**City of Biddeford
Planning Board**

November 20, 2024 at 6:00 PM
City Hall Council Chambers & Zoom

- 7.c 2024.59 The Planning Board will review a Preliminary Subdivision Plan for Acorn Engineering on behalf of 1921 Pepperell, LLC to redevelop buildings 19 & 20 of the Pepperell Mills into 64 residential units with utility infrastructure improvements. The property is located at 6, 32-40 Main Street (Tax Map 71, Lots 10-7, 10-4 & 10-1) in the MSRD-3 & Shoreland Overlay Zone.

7.e 2023.29 The Planning Board will review a request for Preliminary Approval for 209 condos in Phase I from One Diamond, LLC. The location of the property is considered 1 Diamond Street with the subdivision running from Elm Street to Main Street further identified as tax map 40, lots 25-2, 25-2, 24. 25 & 74; tax map 37, lots 34 & 35 in the MSRD-3 Zone.

SHEET C-310

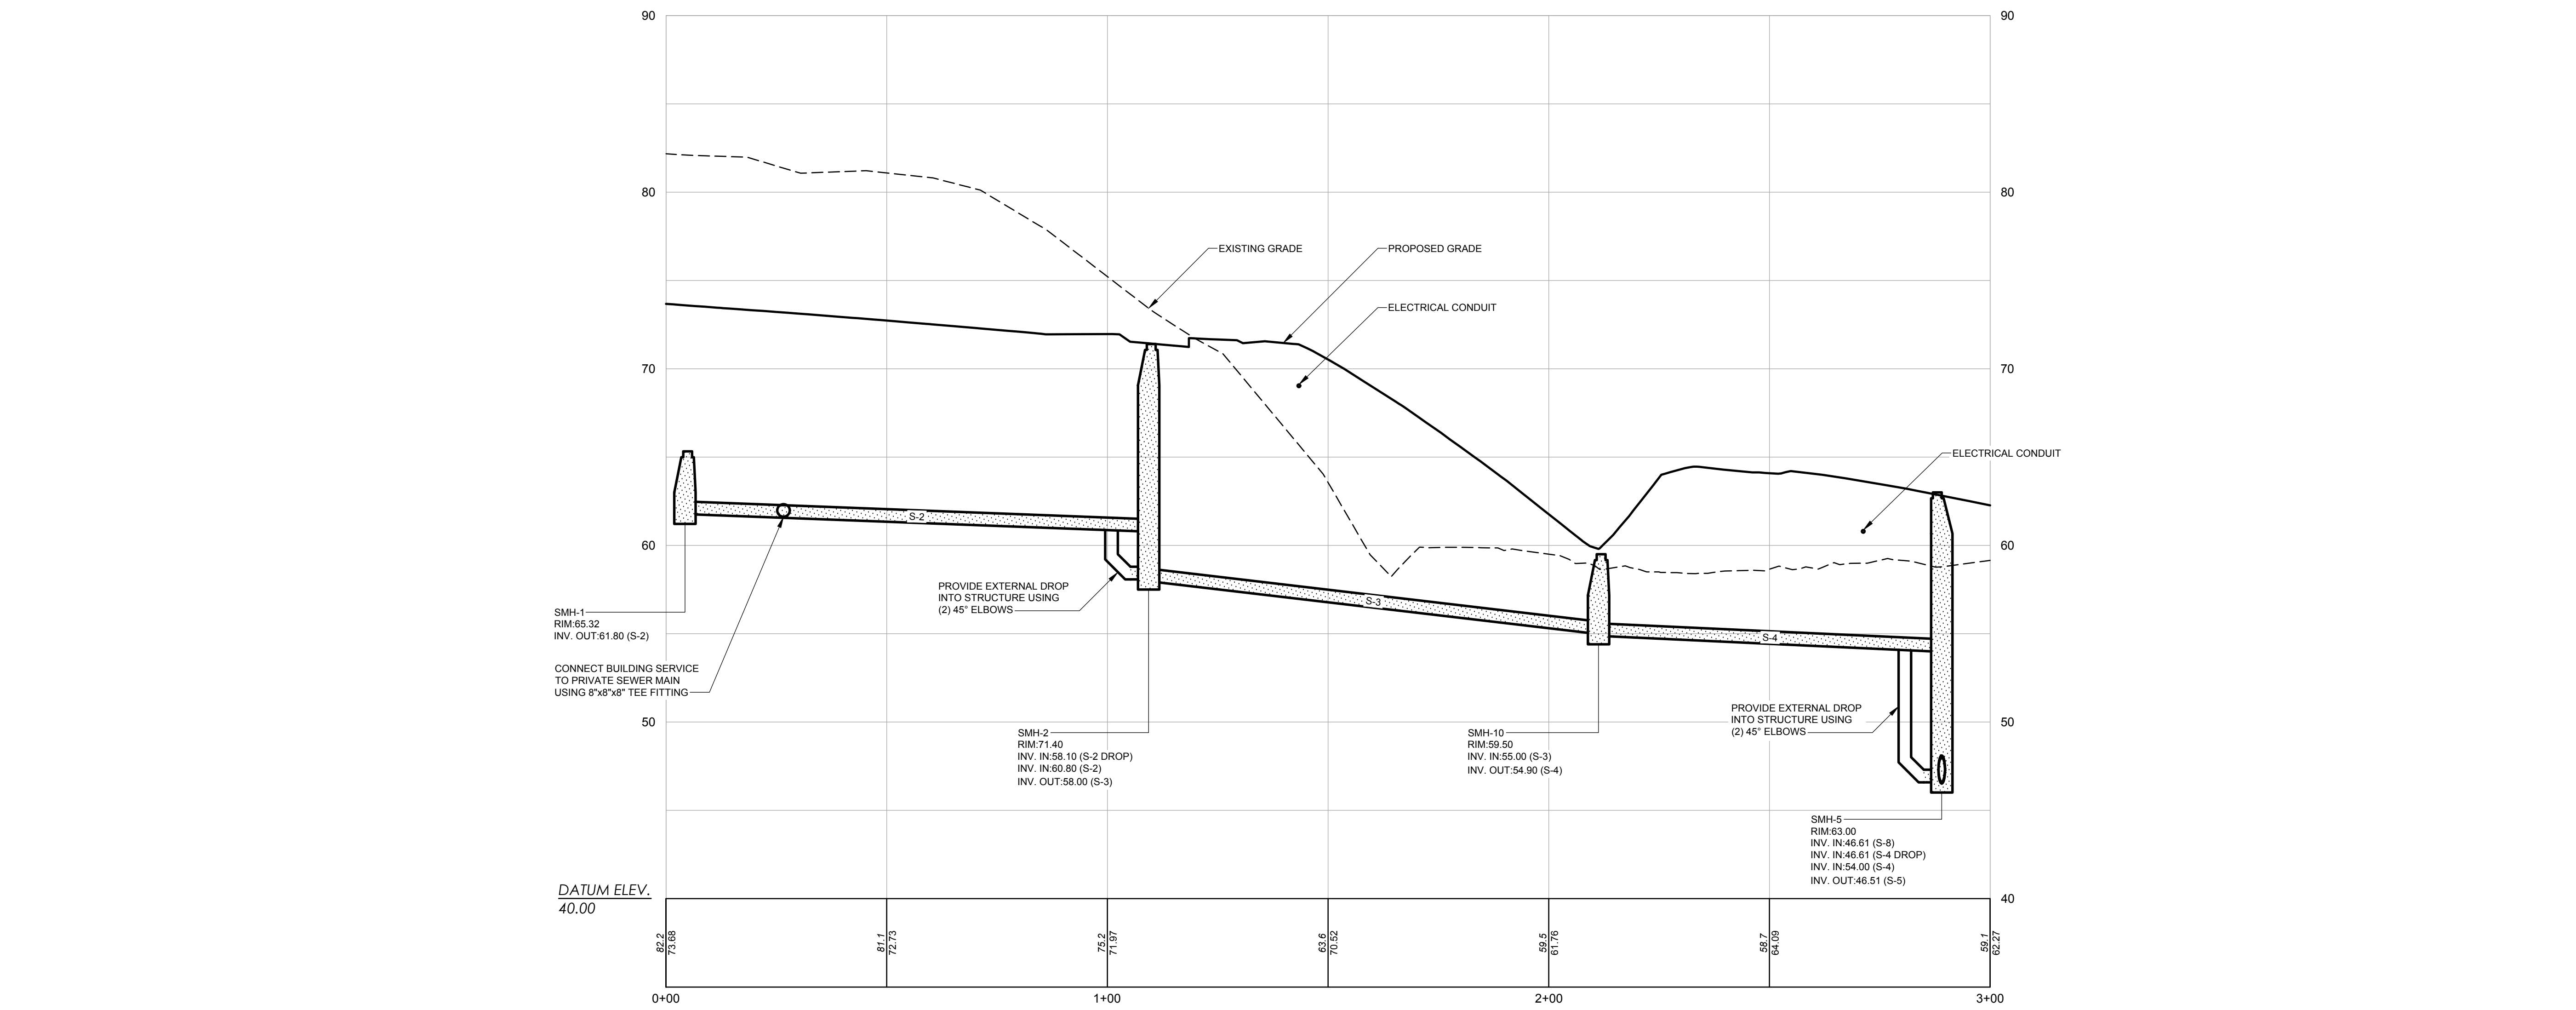
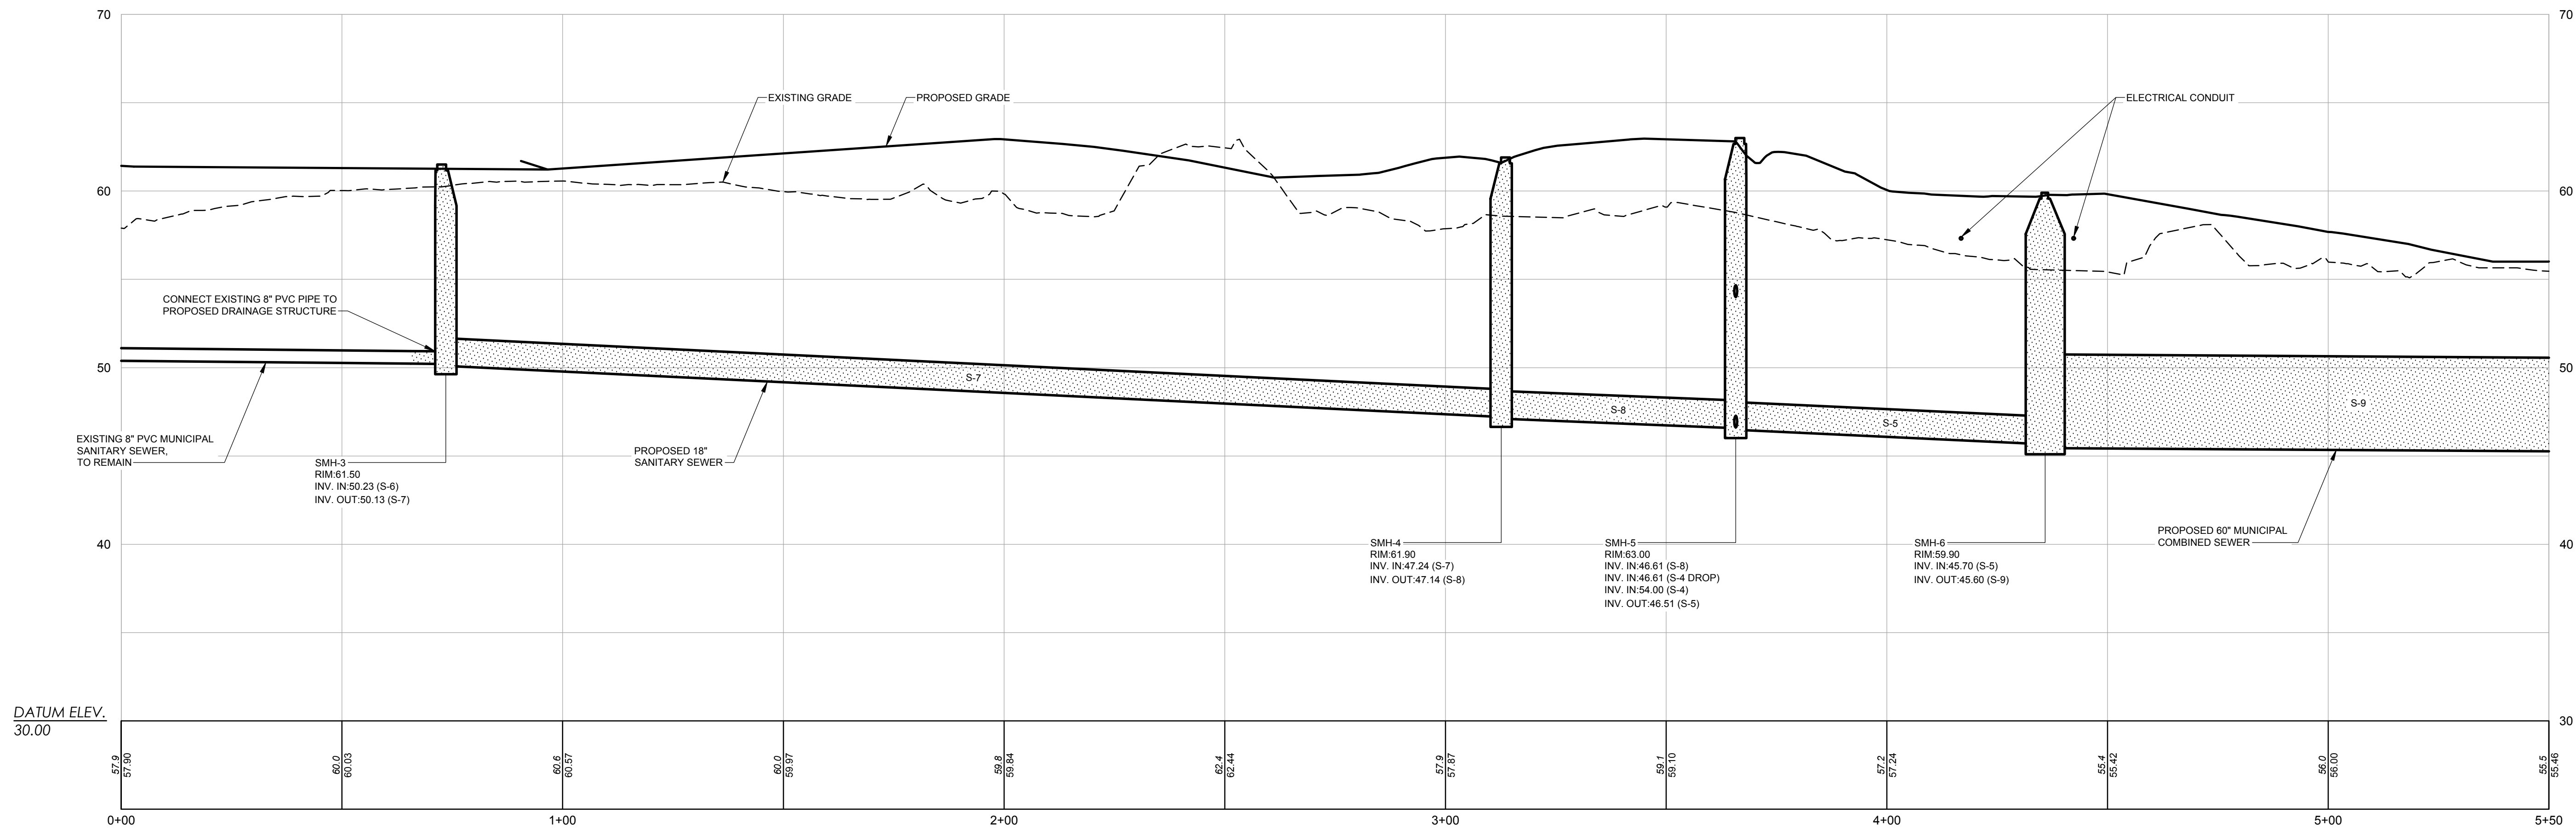
The revised plan set now includes profiles for utility main-line runs. The stormwater outfall is shown on Sheet C-309 the remaining utility profiles are presented on sheets C-306 through C-311.

Information on this sewer replacement is now presented on revised sheet C-303, with profiles on C-310 and C-311.
